**DEVIATION REQUEST  
AND DECISION FORM**

Project Name : Hay Creek Valley Subdivision  
 Schedule No.(s) : 7133007014, 7133000001, 7100000270, 7100000267, 7100000268, 7100000269  
 Legal Description : See attached

## DEVIATION REQUEST AND DECISION FORM

HAY CREEK VALLEY SUBDIVISION  
 PRELIMINARY PLAN

## SP03

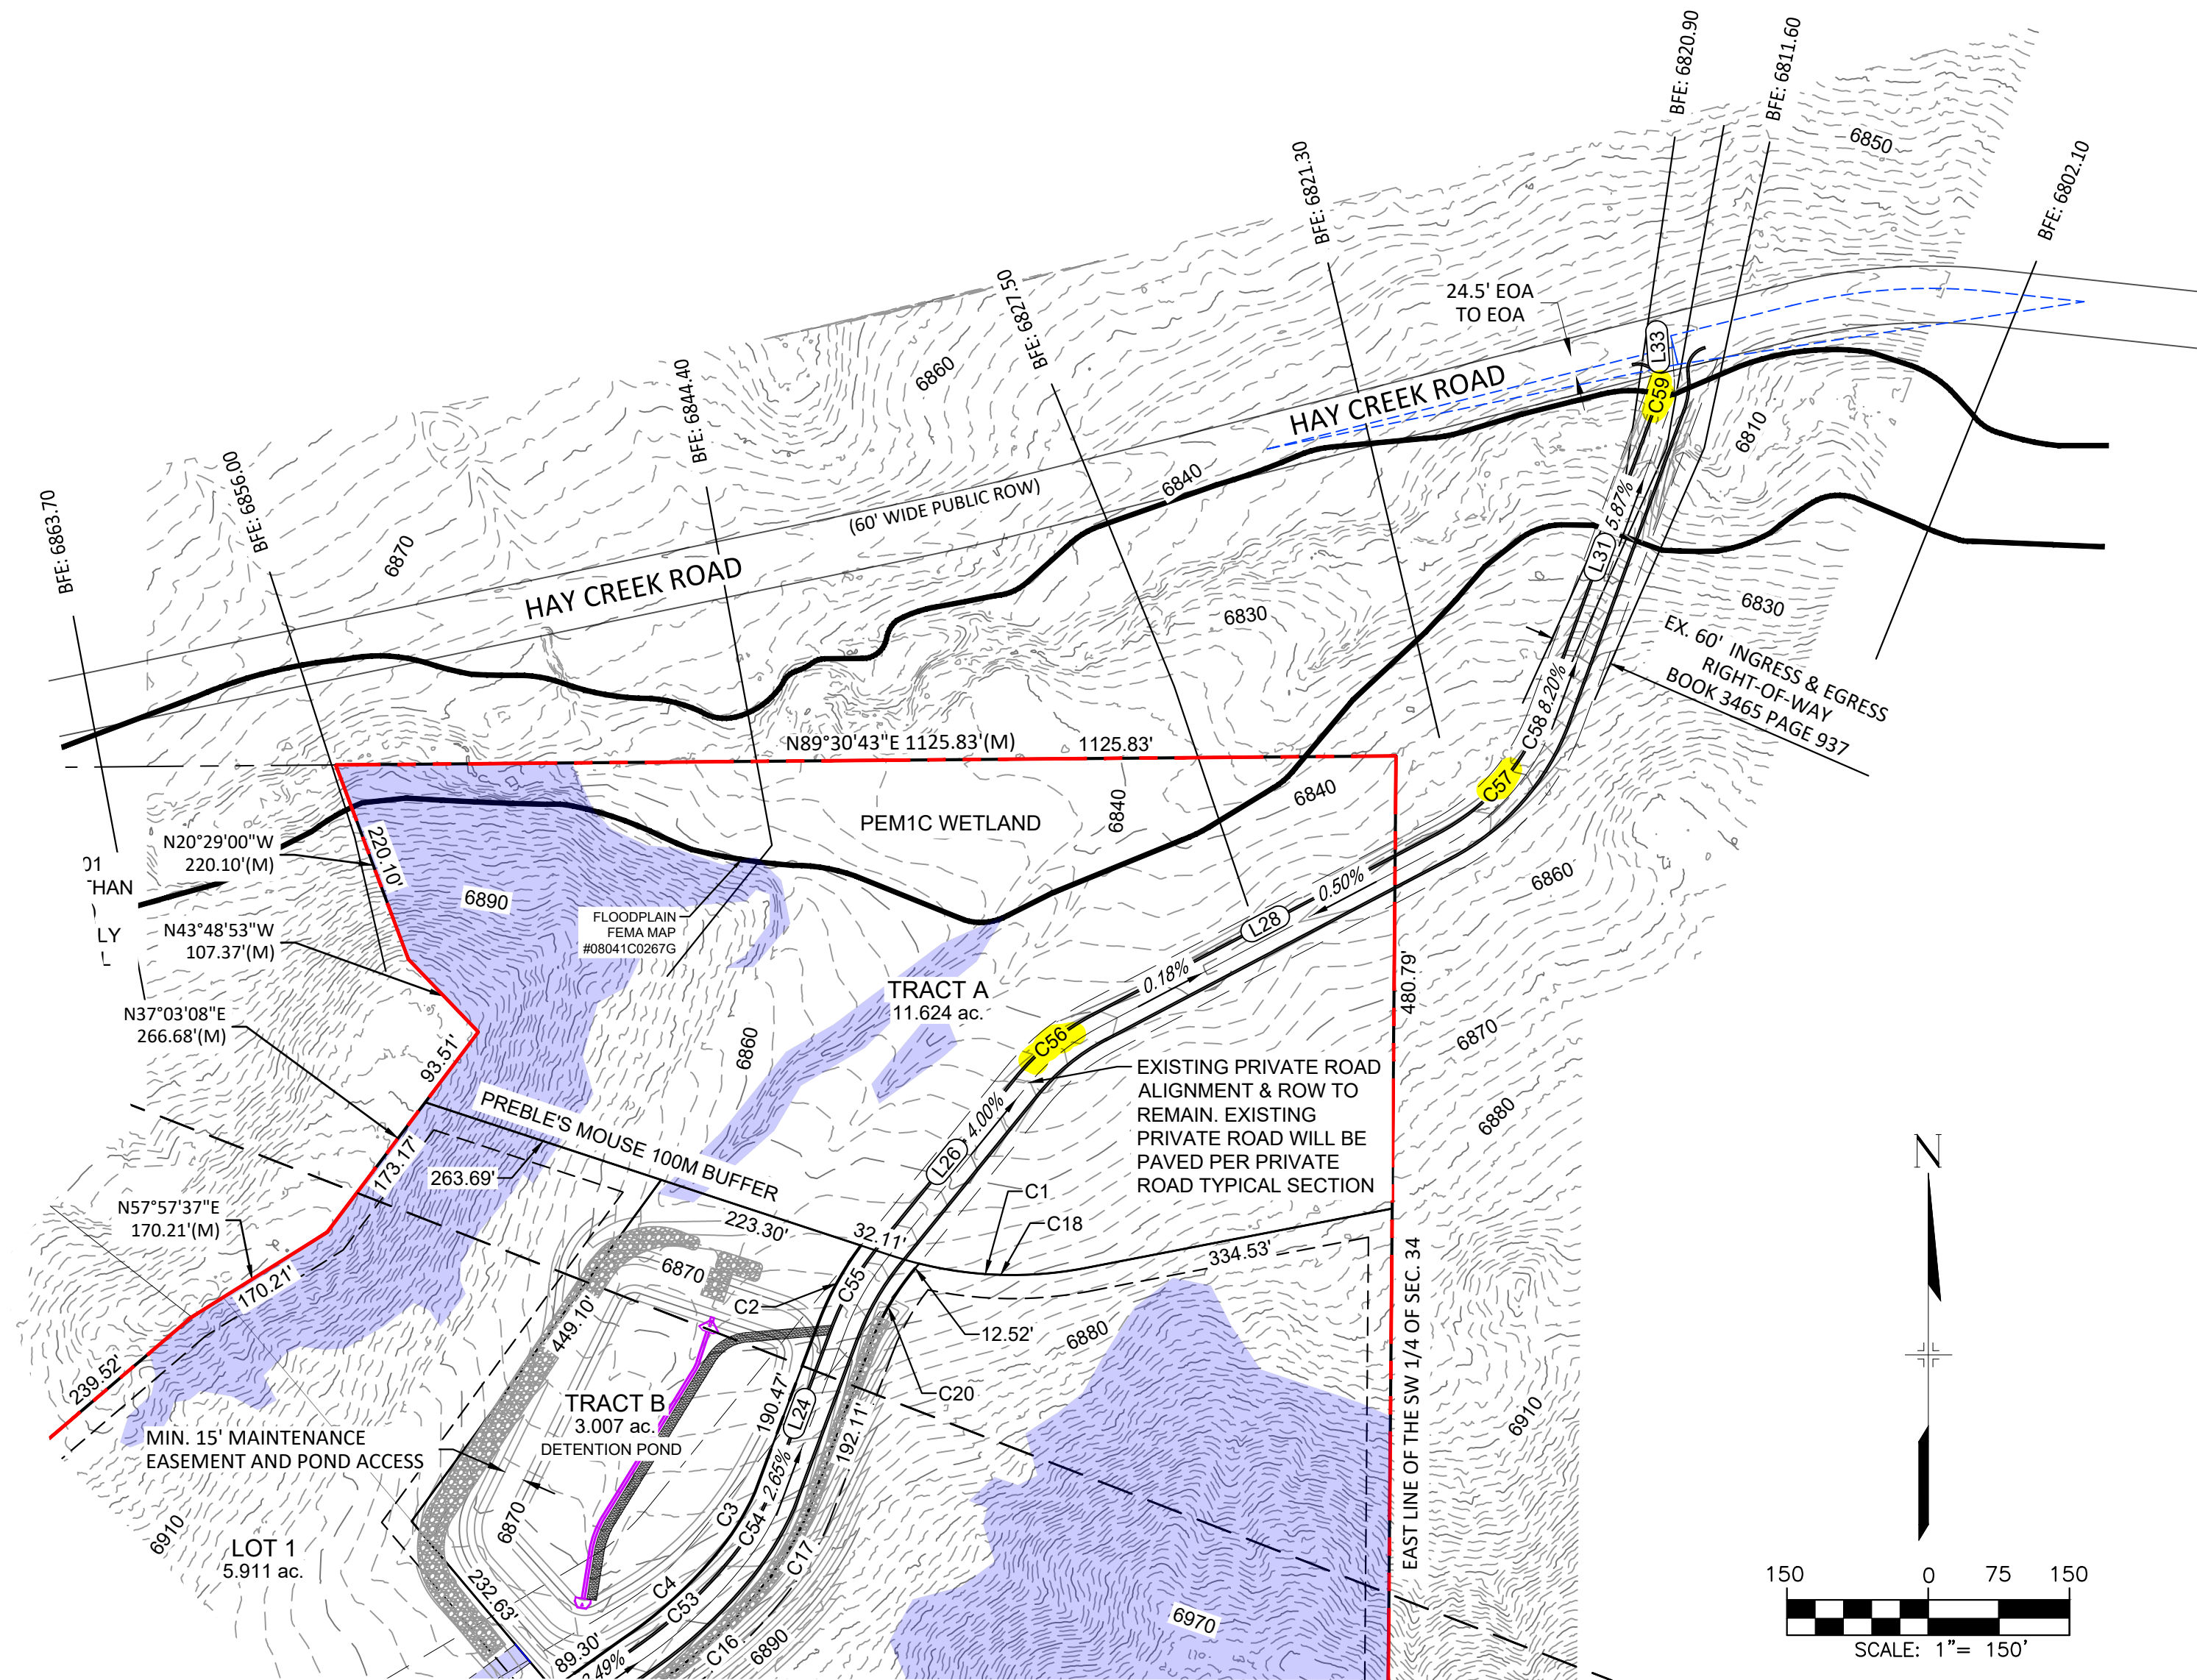
Approved deviation only applies to curves C56, C57, C59 which are located in an existing easement offsite as described above.

→ Roadway alignment at curve C54 must be revised with the subsequent final plat application to meet criteria.
